SERVICE LETTER: 37

TITLE: Installation-oil filter, float hydraulic system

EFFECTIVITY: Applicable to all Model DeHavilland Twin Otter, Model 300 with Wipline Model 13000 Floats Installed. S/N 1 thru 22

WIPPAIRE INC
 8520 RIVER ROAD, INVER GROVE HEIGHTS, MN. 55076
 TITLE INSTL - FILTER HYDRAULIC PUMP
 PROJ NO. 601-2287

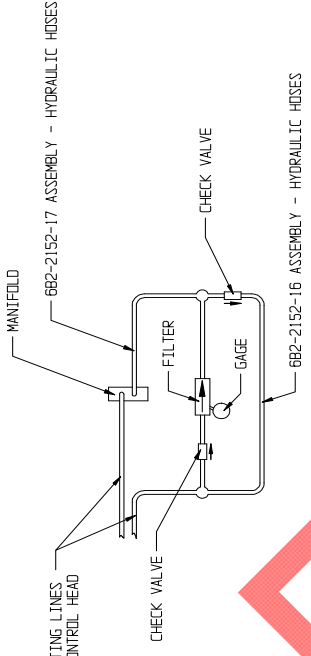
REASON: Hydraulic oil contamination in the landing gear hydraulics.

Hydraulic oil contamination will develop over time in your hydraulic system. This is a variety of dirt, water, and fungi (black Mass), and this will plug the filter screen in your hydraulic oil tank.

The installation of this oil filter system will filter out this contamination and prevent hydraulic pump damage.

METHOD OF COMPLIANCE: Installation per Installation drawing 6D1-2287

- INSTALLATION PROCEDURE
1. REMOVE AN3-SA BOLT, AN3-6A BOLT ON 5B2-762 ASSY-MANIFOLD
 2. DRILL OUT TWO RIVETS ON 6C3-2151 BRACKET (NOTED)
 3. DIASSEMBLE FILTER ADAPTER FROM 6B3-2285 MOUNT IF NECESSARY
 4. LOCATE & CLECD 6B3-2285 MOUNT BETWEEN MANIFOLD AND 6C3-2151 BRACKET
 5. USE MOUNT TO MATCH DRILL 8 (#30 (.128) DIA) HOLES INTO 6C3-2151 BRACKET
 6. RIVET 6C3-2151 BRACKET AND 6B3-2286 MOUNT USING AM470A04 RIVETS (NOTED)
 7. REMOUNT MANIFOLD USING HARDWARE NOTED ON 602-2286 ASSEMBLY - FILTER - HYDRAULIC PUMP
 8. REASSEMBLE FILTER ADAPTER TO MOUNT IF REMOVED AND SAFETY WIRE

NOTE:
 △ OPPOSITE INSTALLATION, IF EXISTING LINES COME TO PUMP ASSEMBLY FROM REAR OF AIRCRAFT. ROTATE FILTER ADAPTER 180° AND CHANGE HYDRAULIC LINES TO ACCOMMODATE FLOW DIRECTION
 2. DO NOT BACK FLUSH FILTER
